Figure ES1 Conceptual model of chemical concentrations observed in CSG well waters

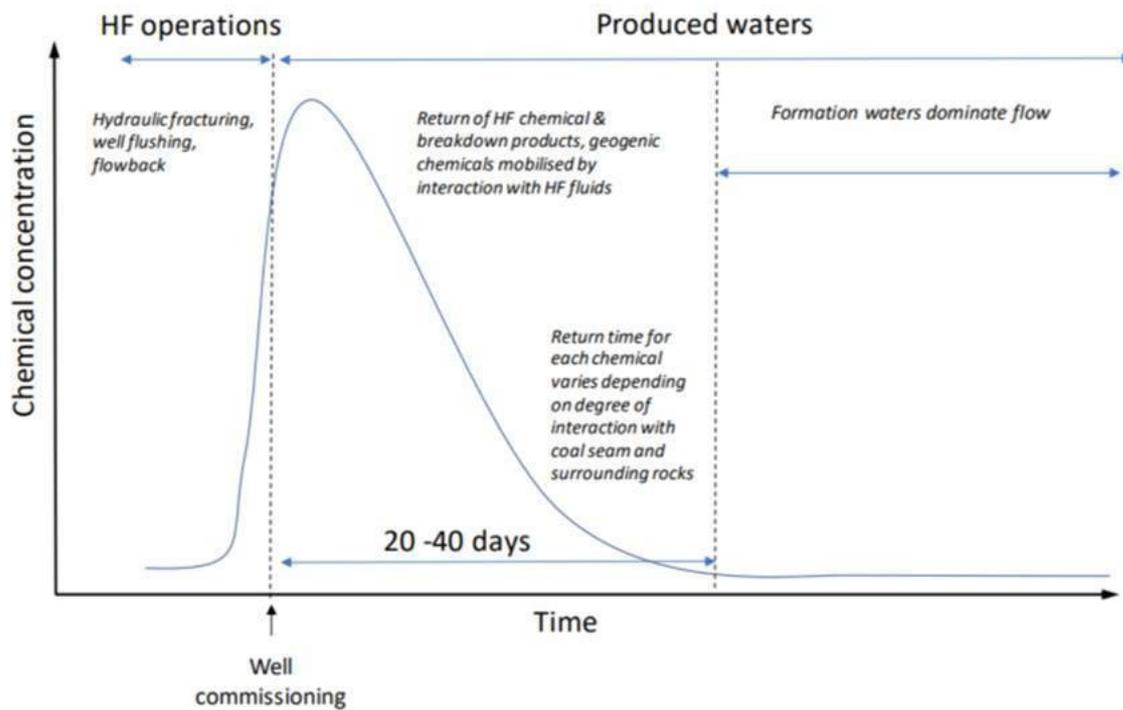
6. The application material indicates that the Durham Ranch 97 “parallel injection and production” relies on up to nine months of injection, contemporaneous and followed by up to 27 months of recovery. The application material states that the current groundwater flow direction is toward the proposed trial wells in both PL204 and PL195.

- Confirmation of the flow directions and flow rates (with confidence) at the release depths in Durham Ranch 97 and Durham Ranch 98.
- Details to confirm that the mathematical calculations that verify whether the 36 months of production and recovery will be sufficient to capture the fluid injected during the initial 9 months, and that the flow direction and rate have not overtaken the recovery potential. The flow rate and direction must account for the anticipated / known production influences in the vicinity.
- Provide the location (coordinates) and depth of Durham Ranch 98.

As described in the application, injection would generally occur under gravity. The relatively short injection period compared to the production period, and network of surrounding production wells would ensure recovery of injection fluid regardless of flow direction or injection rates. This assertion is supported by the CSIRO report *Assessing the potential impacts of hydraulic fracturing on water and soil quality in the vicinity of well sites in the Surat Basin, Queensland* (<https://gisera.csiro.au/wp-content/uploads/2020/04/Water-12-Milestone-7-final-report.pdf>). Figure ES1 and Figure 34 of Section 6 of this CSIRO report demonstrates the relatively short time period (e.g. < 40 days) for return of injection fluids from coal seams due to operation of production wells.
